Motorsport UK Championship Permit Number(s)

CHAMPIONSHIP BULLETIN: 03

Micro Max UK - Mini Max 950

5.8 Carburettor

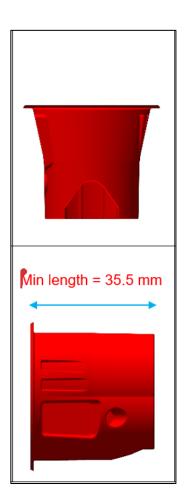
Clarifications listed in red in the table/photo below.

ROTAX part number: 267536. No modifications are allowed, the ribbed surface on the inlet is to help ensure dimensions have not been modified.

Please note the new measurement of 35.5mm as listed below.
